S.B. V2500-NAC-29-0001 Revision No 1

<u>Subject</u>: Nacelle Service Bulletin No. V2500-NAC-29-0001 Revision No 1 dated

- (1) To delete references to I.D.G. cooling pipe in Section 2, Accomplishment Instructions (including figures) and also to amend clipping configuration.
- (2) To add additional Accomplishment Instructions and figure for spares replacement.
- (3) To amend information given in Planning Information.

NACELLE - HYDRAULIC POWER - HYDRAULIC HOSE TO LOW PRESSURE SWITCH - REPLACEMENT OF.

REMOVAL OF DEFECTIVE HYDRAULIC HOSE FIGURE 1

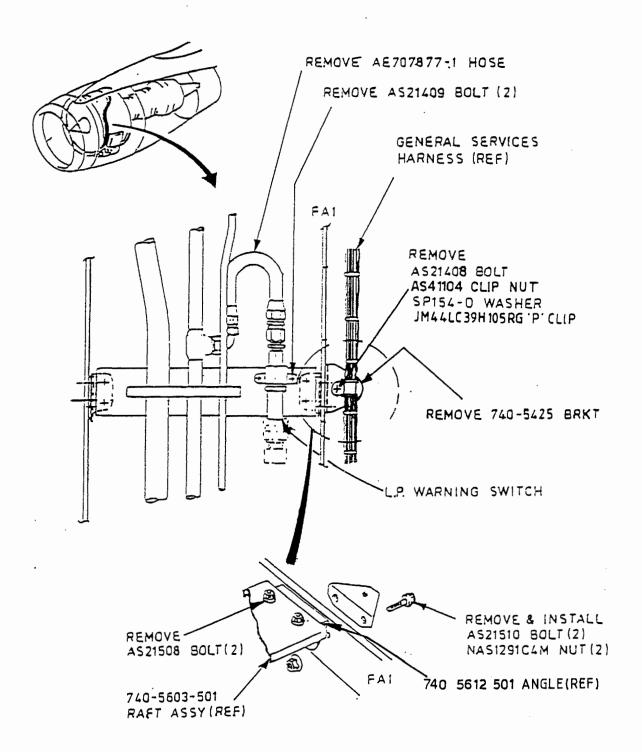
- (1) Drain the hydraulic fluid from the pressure tubes as follows:
 - (a) Put a clean container (minimum capacity of 2 US gallons) in position below the hydraulic pump.
 - (b) Disconnect the AE707875-1 pressure hose from the hydraulic pump.
 - (c) Let the hydraulic fluid drain into the container.
 - (d) Connect the AE707875-1 pressure hose back to the hydraulic pump and torque to 855-945 lb-in (96.6-106.8 N.m.)
- (2) Remove and discard the AE707877-1 hose. Install blanks in the open couplings (Refer to Figure 1).

INSTALLATION OF REPLACEMENT HYDRAULIC HOSE FIGURE 2

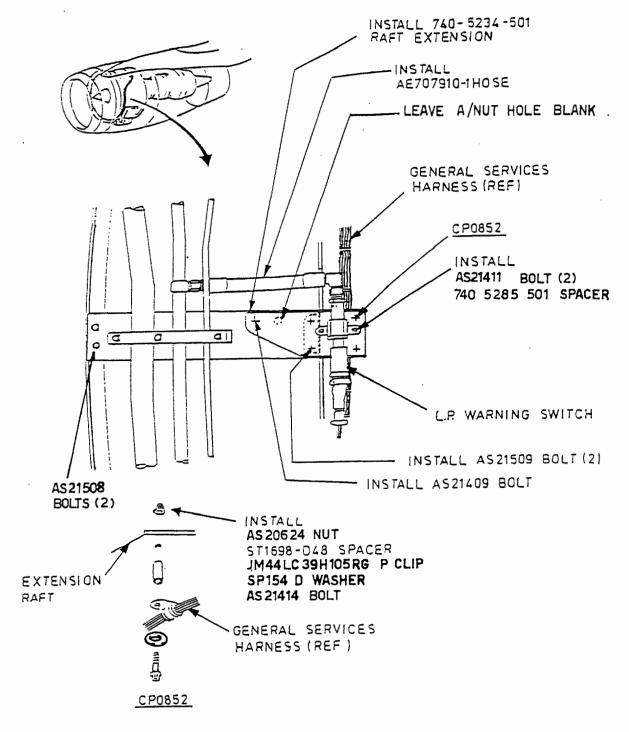
- (7) Install the 740-5234-501 extension raft to the 740-5603-501 raft assembly with two AS21509 bolts and one AS21409 bolt. (Refer to figure 2). Torque the AS21509 bolts to 100 lb-in. (11.3 N.m.) and the AS21409 bolt to 40 lb-in. (4.52 N.m.).

- (11) Install the LP warning switch and 740-5285-501 spacer to the 740-5234-501 extension raft with two AS21411 bolts. Torque the bolts to 40 lb-in. (4.52 N.m.) Refer to figure 2>

- (16) Remove the blanking plugs installed in paragraph 2 B (2). Install the new AE707910-1 hydraulic hose. (Refer to figure 2). Measure the clearance between the hydraulic hose and the engine where the hose lies closest to the engine. Minimum clearance of 0.078 inch (2.0 mm) must be maintained. Loosen the retaining hardware securing the rigid tube retaining blocks. Reposition the supply tube to gain at least minimum clearance. Secure the retaining blocks. Torque the two end couplings of the hose to 135-145 lb-in. (15.3-16.4 N.m). (Refer to Figure 5.)

REVISED ROUTING OF THE LP WARNING SWITCH FIGURE 3

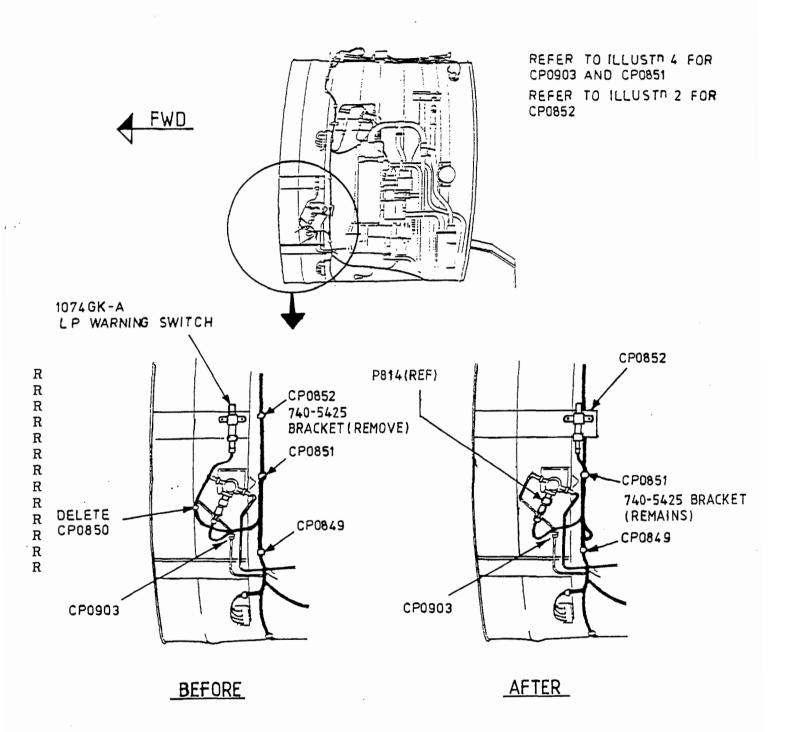
- (8) Disconnect the harness assembly for the LP warning switch from clipping point CP0850. (Refer to figure 3). Discard the AS21408 bolt, SP154-D washer, and JM44LC39H101RG 'P' clip from that position.

- (9) Attach the general services harness to the 740-5234-501 extension raft (clipping point CP0852) with an AS20624 nut, ST1698-D48 spacer, JM44LC39H105RG 'P' clip, and an AS21414 bolt as shown. Tprque the nut to 40 lb-in. (4.52 N.m.)

- (10) Disassemble clipping point CP0903 (Refer to figures 3 and 4). Remove the harness assembly for the LP warning switch from the JM44LC39H102RG 'P' clip and assemble the clipping point back to the pipe assemblies as shown. Torque the nut to 40 lb-in. (4.52 N.m.).

DISASSEMBLY/ASSEMBLY OF CLIPPING POINTS CP0851 AND CP0903

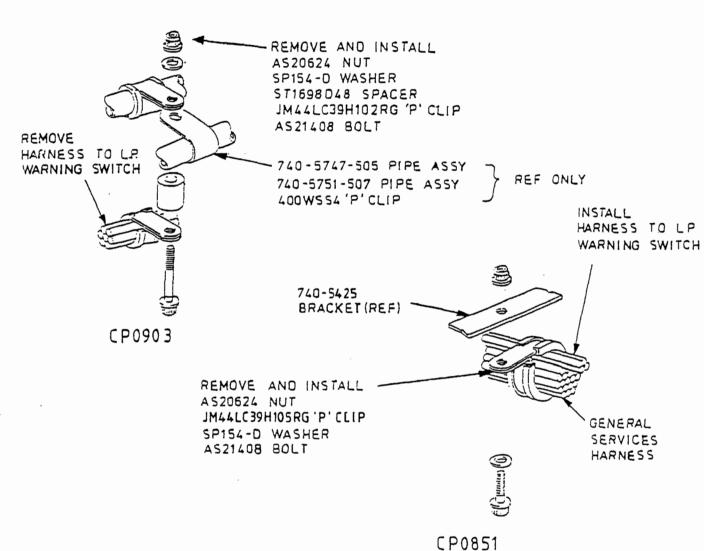
- (12) Disassemble clipping point CP0851 from the 740-5425-501 bracket (Refer to Figures 3 and 4).
- (13) Install the harness assembly for the LP warning switch along the general services harness. (Make a loop in the harness when routing). Attach the harness at clipping point CP0851 with the JM44LC39H105RG 'P' clip, AS20624 nut, SP154-D washer, AS21408 bolt; (removed in paragraph 2 B (12)). Torque the nut to 40 lb-in (4.52 N.m.).

INSTALLATION OF REPLACEMENT RAFT ASSEMBLY FIGURE 6

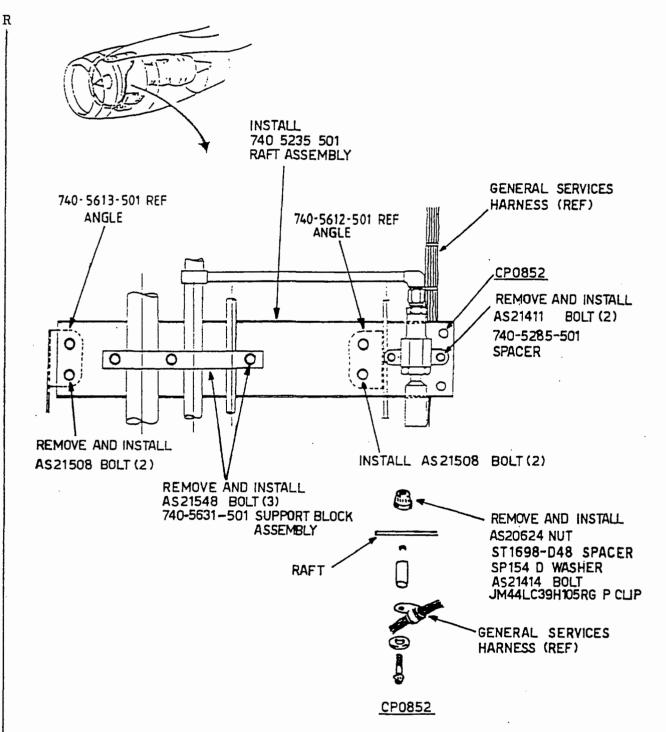
- (3) Remove three AS21548 bolts to release the support block assembly.
- (4) Remove two AS21509 bolts and one AS21409 bolt to release the 740-5234-501 Raft extension from the 740-5603-501 Raft assembly (refer to figure (2)). Discard the Raft extension and the bolts.

- (5) Remove two AS21508 bolts to release the 740-5603-501 Raft assembly. Discard Raft assembly.
- (6) Install the 740-5235-501 Raft assembly to the 740-5613-501 and 740-5612-501 angles with four AS21508 bolts (Refer to figure 5). Torque the bolts to 100 lb-in (11.3 N.m).

- (7) Install the 740-5631-501 Support block assembly to the 740-5235-501 Raft assembly with three AS21548 bolts. Torque the bolts to 100 lb-in (11.3 N.m).

- (8) Install the LP warning switch and 740-5285-501 spacer to the Raft assembly with two AS21411 bolts. Torque the bolts to 40 lb-in (4.52 N.m).
- (9) Assemble clipping point CPO852 to the Raft Assembly. Torque nut to 40 lb-in (4.52 N.m).
